Operational Readiness Clearance (Non-beam operation)  
FEE Crates and Power Distribution in Final Location  
2 Dec 2010

AUTHORIZATION TO PROCEED WITH THE UNATTENDED OPERATION OF FEE CRATES AND  
POWER DISTRIBUTION FOR DECAM TELESCOPE SIMULATOR IN FINAL LOCATION, SIDET LAB A

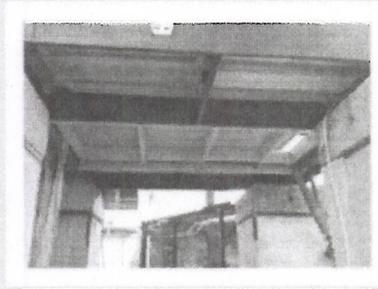
Leo , I visited the DECam Telescope Simulator this morning and talked with the techs.

I do not have a problem with placing a CO2 extinguisher on the platform since the techs are trained. The physics that will be working on the platform needed to be trained to leave.

1. The ladder being used is much to short. It need to be at last 36" beyond the working height. I would recommend a moveable stair of the proper height be used since there will be a number of people will be on and off the platform.
2. The wood floor and bracing on the platform needs to be painted with fire retardant paint.
3. I asked the Fire Techs to install a temporary Pull station tied to FIRUS on each side of the platform to be used if there is a fire or other emergency on the device.
4. The DECam Telescope Simulator is equipped with a rack style smoke detector shut off for the electronic. I would suggest a manual crash button also be installed.

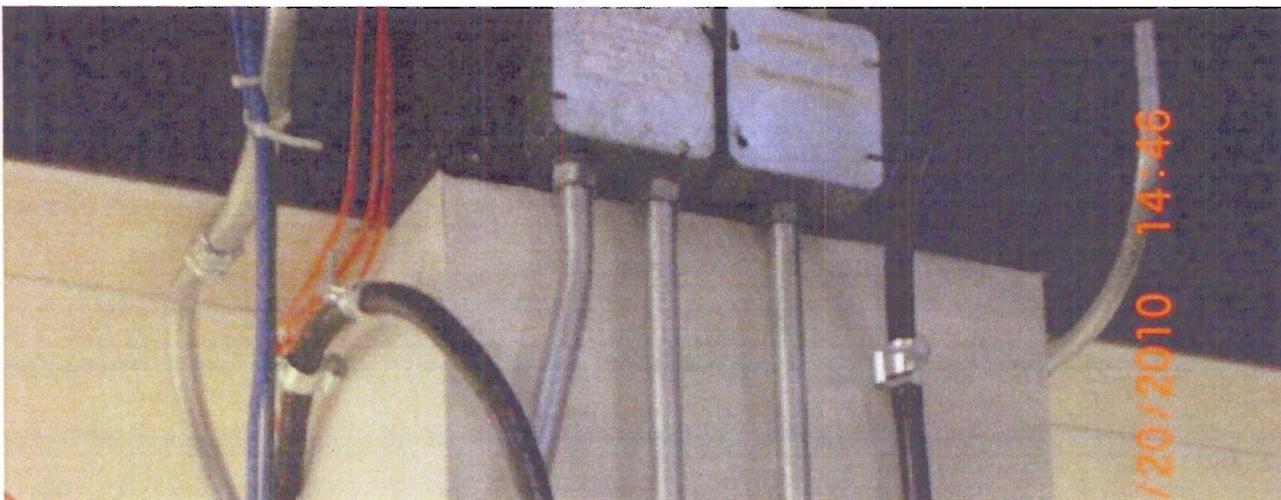
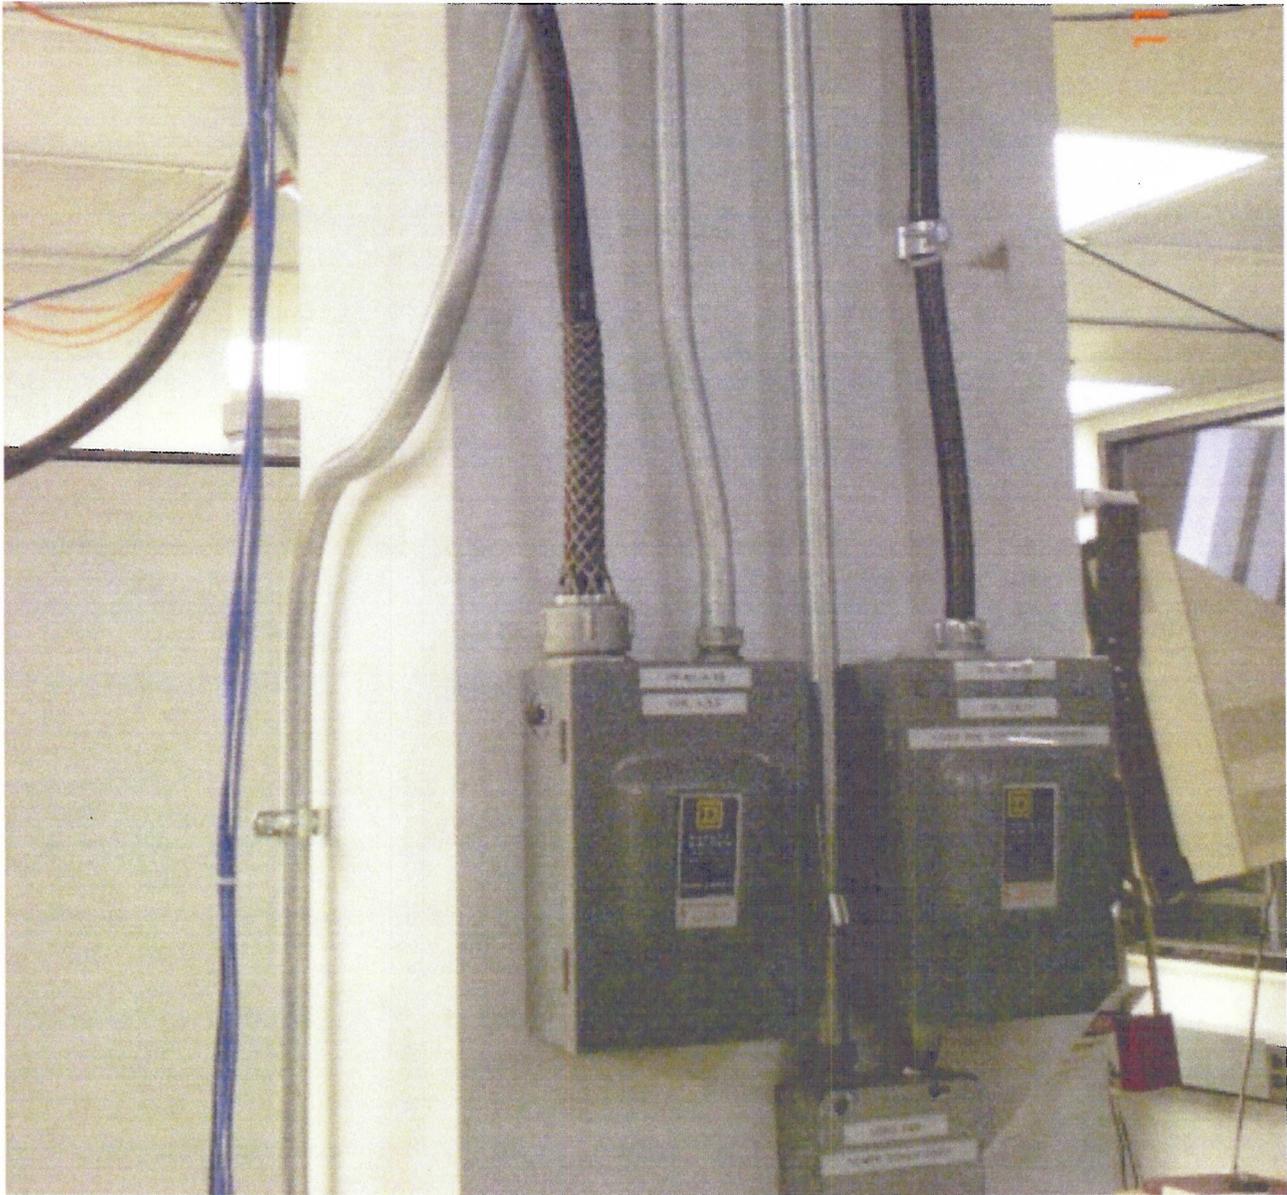
Yes. It is not a "button" per say but I have two emergency safety shut-off switches, mounted on the column next to the operations area (see the attached picture), for all the power in the cage and for the hexapod control rack. This also enables the power to be shut off in an emergency even if the equipment in the cage cannot be accessed. However, these shut-off switch boxes should be labeled more clearly...a situation I will remedy.

4. The **DECam Telescope Simulator** is equipped with a rack style smoke detector shut off for the electronic. I would suggest a manual crash button also be installed.
